schemata
workshop velmeir companies
cvs pharmacy west seattle

4722 fauntleroy way sw
seattle, wa 98126

early design guidance
DPD project # 3015817 + 3019746

25 June 2015 EDG meeting 2

enhancing the south elevation

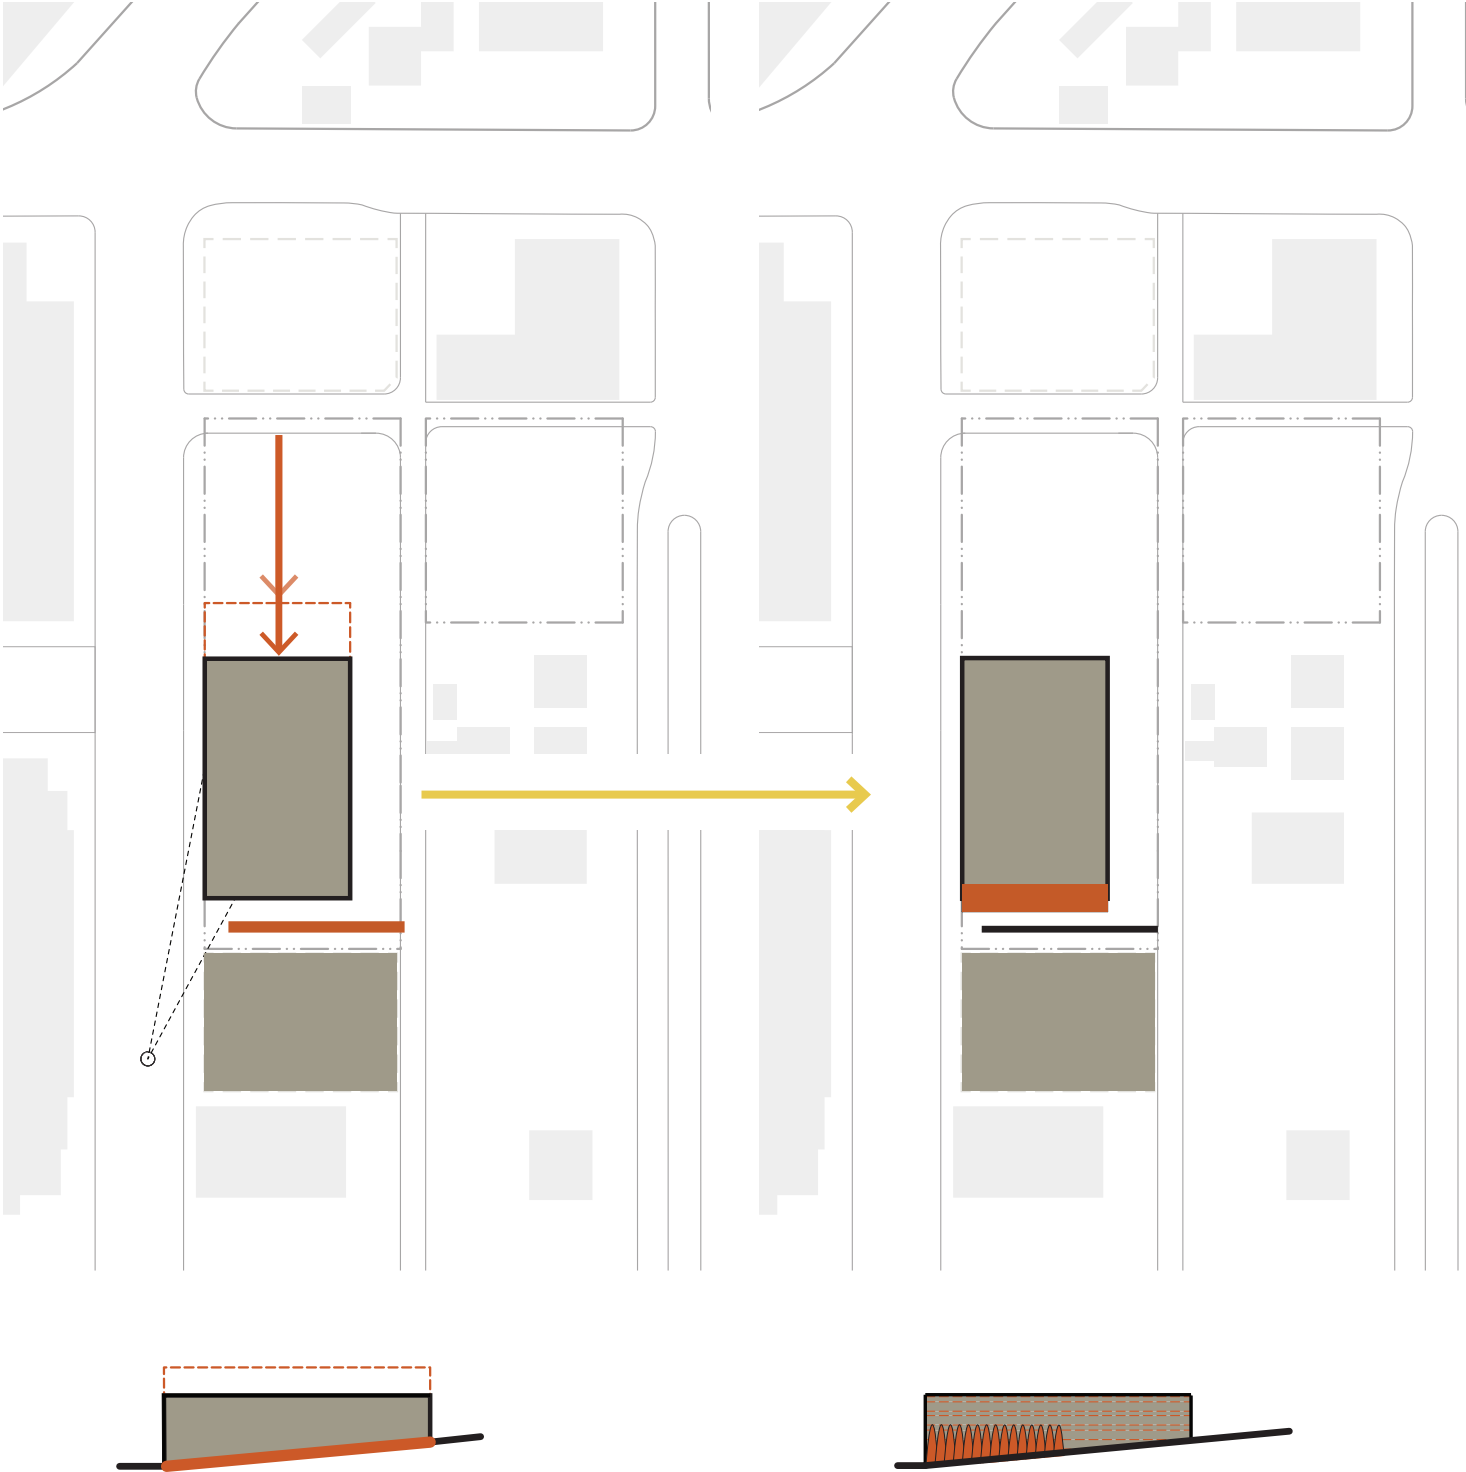
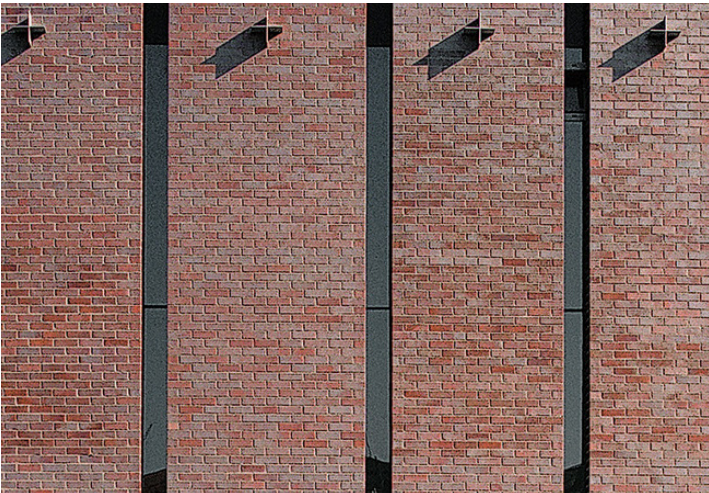
priorities & recommendations: 2g, 3a, & 4b

- The building moves to the south, reducing the amount of south elevation visible once future development occurs
- Site grading adds depth and layering
- Visible building materials will have quality and relief
- Planting will further screen the wall

enhancing the 5th facade

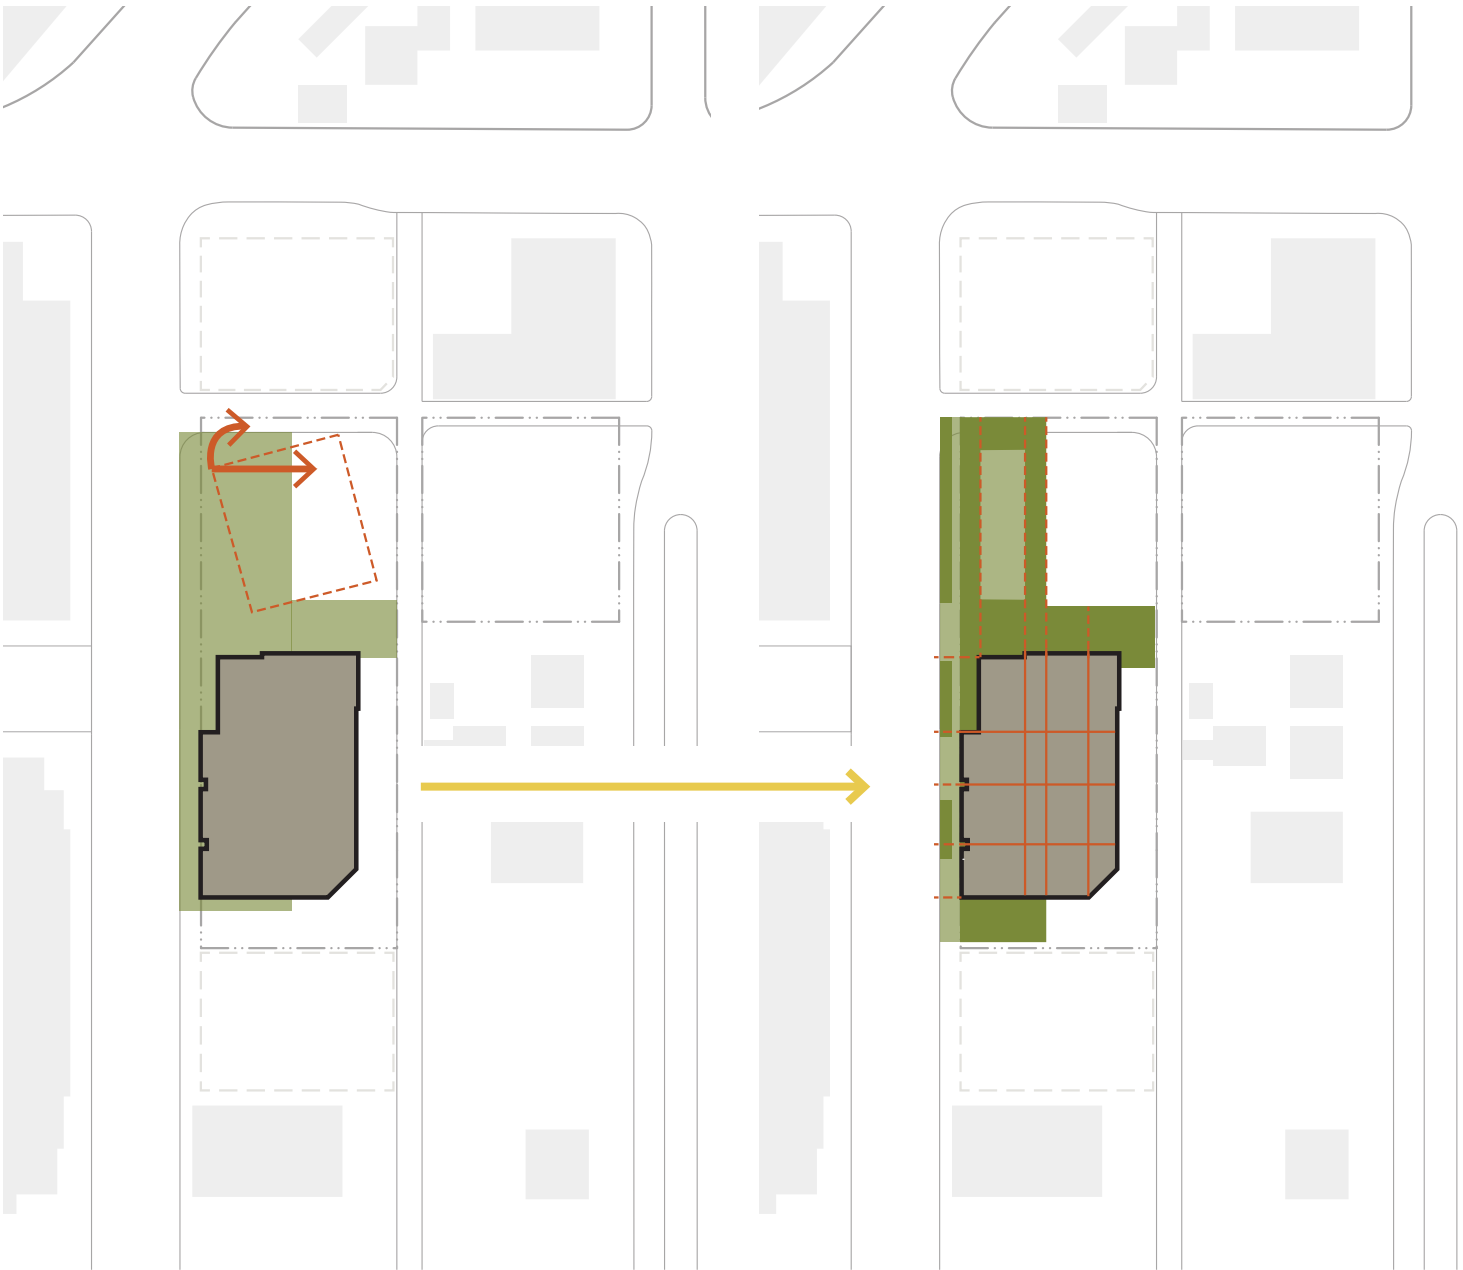
priorities & recommendations: 21a, 1b, 1c, 2f, 3a, 3b

- Proposed northwest parking area is rotated from EDG 1 configuration and moved east
- Landscape architecture generates roof patterns. Formed by contrasting colors of roofing membrane
- Pocket park is extension of the building
